**EPA Superfund  
Record of Decision:**

**Oak Ridge Reservation (USDOE)  
(Union Valley Upper East Fork  
Poplar Creek Characterization Area)  
Oak Ridge, TN  
7/10/1997**

**Record of Decision  
for an Interim Action for Union Valley,  
Upper East Fork Poplar Creek Characterization Area,  
Oak Ridge, Tennessee**

**Date Issued—April 1997**

Fig. 2.2

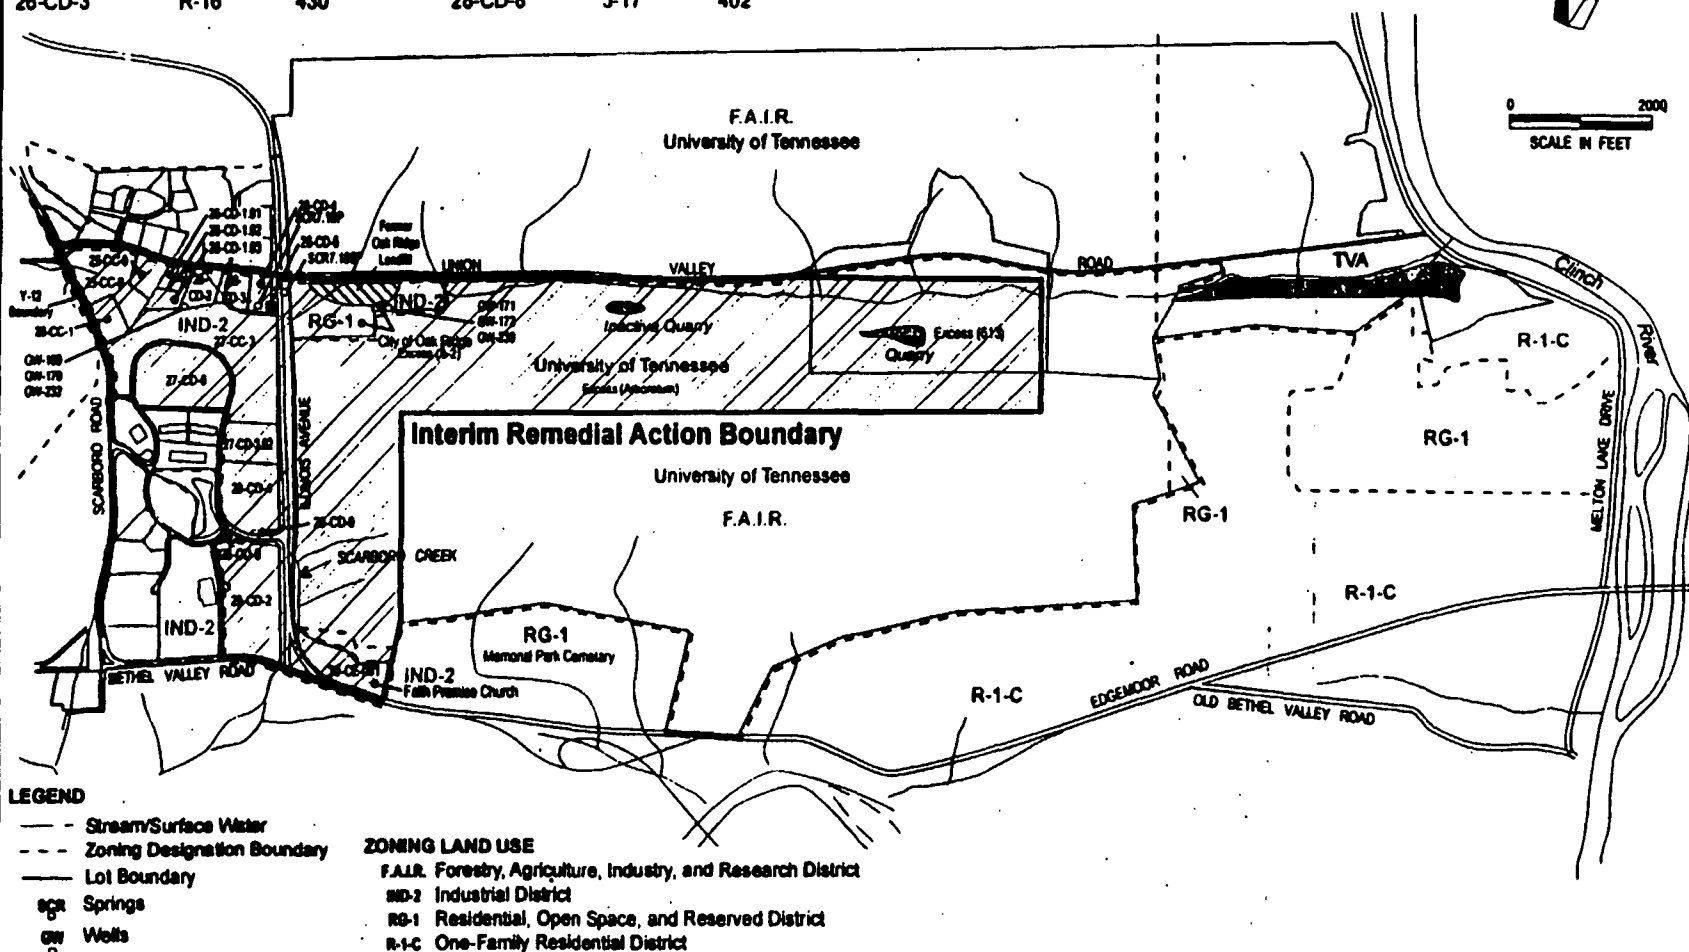
Page 5, Summary of Risks, Paragraph 4: In the last sentence, it is stated that "... some constituents could be found to originate from the municipal landfill or from other sources and would be outside the scope of this interim proposed plan." Although the municipal landfill and other sources may be outside of the scope of the plan, they are still a concern of the public. Therefore, the responsible local government agency should be notified and reference to this notification should be included in the plan. Please identify the municipal landfill and show the location.

*Response:* The golf driving range (119 Union Valley Road), which is north of and adjacent to the UT Arboretum, is located on the former Oak Ridge landfill. The location is shown in Figure 2.2 of this ROD. The landfill reportedly received municipal solid wastes. According to the Oak Ridge Community Development Office, Management Services, Inc., managed the landfill from the 1940s until it was acquired by the city in 1961. The exact closure date of the landfill is uncertain, but the lease to the driving range started on July 31, 1967. The TDEC Division of Superfund is investigating the landfill.
